JAMES A. FITZPATRICK NUCLEAR POWER PLANT

AMENDMENT TO FACILITY OPERATING LICENSE

Amendment No. 14
License No. DPR-59

ATTACHMENT TO LICENSE AMENDMENT NO. 14
FACILITY OPERATING LICENSE NO. DPR-59
DOCKET NO. 50-333

FIGURE 3.1.1

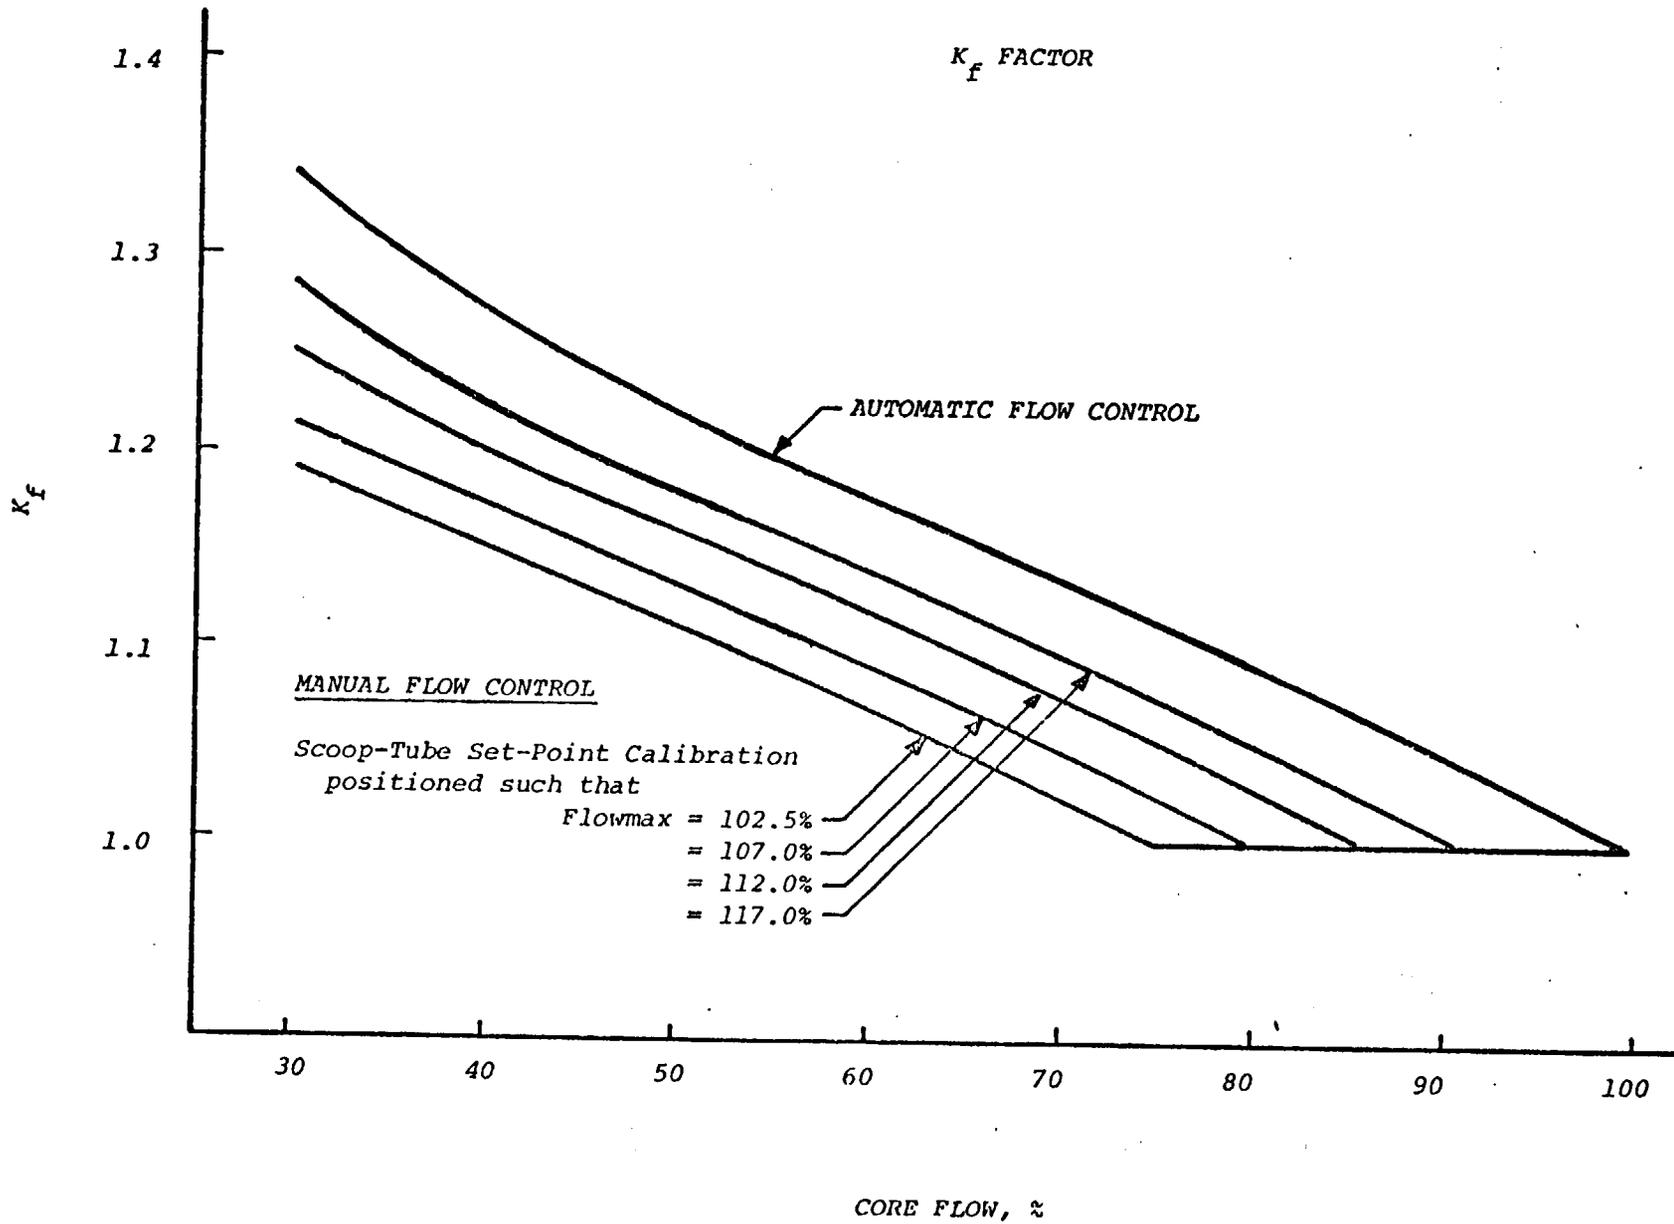
reactor shall be brought to the Cold Shutdown condition within 36 hours. Surveillance and corresponding action shall continue until reactor operation is within the prescribed limits. For core flows other than rated, the MCPR shall be ≥ 1.37 times K_f where K_f is as shown in Figure 3.1.1.

For the limiting transient of recirculation pump speed control failure at lower than rated power and flow condition, the licensee will conform to Technical Specifications limiting conditions for operation, Figure 3.1.1. This requires the licensee to maintain the required operating MCPR greater than 1.37 times the K_f factor for core flows less than rated. The K_f factor curves were generically derived to assure that the

FIGURE 3.5-1 MAXIMUM AVERAGE PLANAR LINEAR HEAT GENERATION RATE (MAPLIHR) VERSUS PLANAR AVERAGE EXPOSURE

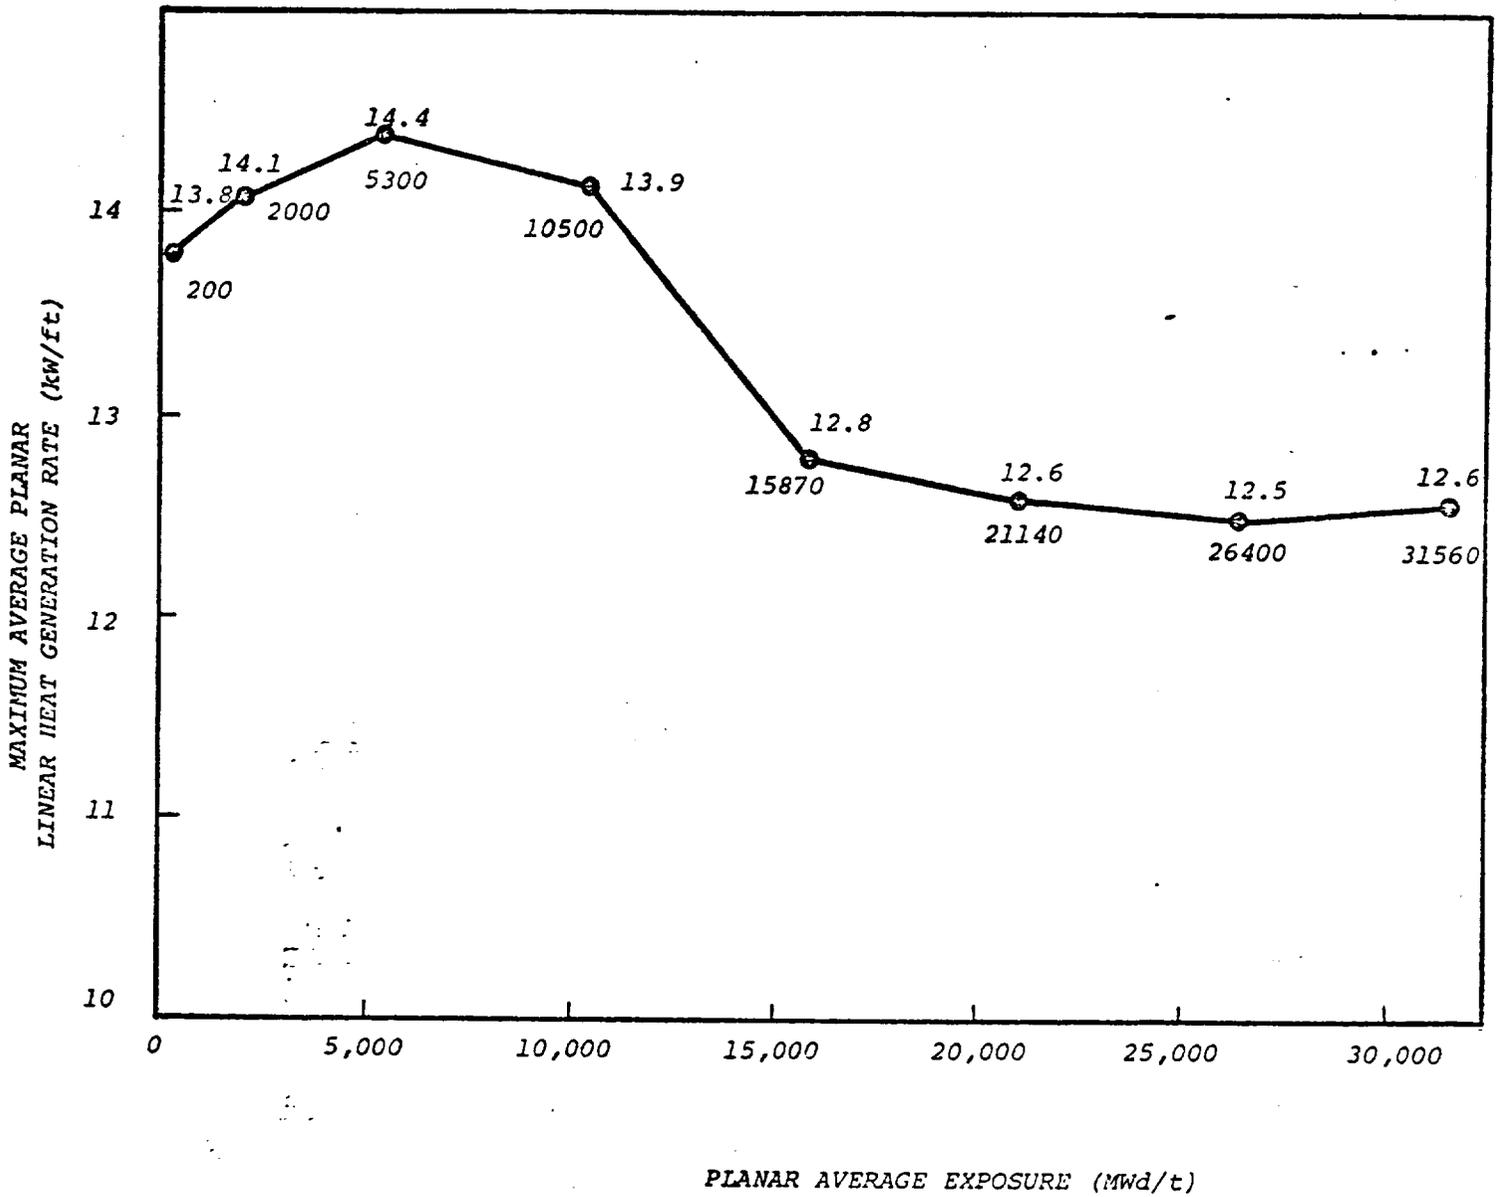
The APLHGR for each type of fuel as a function of average planar exposure shall not exceed the limiting value shown in Figures 3.5.1 and 3.5.2. If at any time it is determined that the limiting value for APLHGR is being exceeded action shall then be initiated within 15 minutes to restore operation to within the prescribed limits. If the APLHGR is not returned to within the prescribed limits within two (2) hours, the reactor shall be brought to the Cold Shutdown condition within 36 hours. Surveillance and corresponding action shall continue until reactor operation is within the prescribed limits.

are within the 10 CFR 50 Appendix K limit. The limiting value for APLHGR is shown in Figure 3.5.1 and 3.5.2.
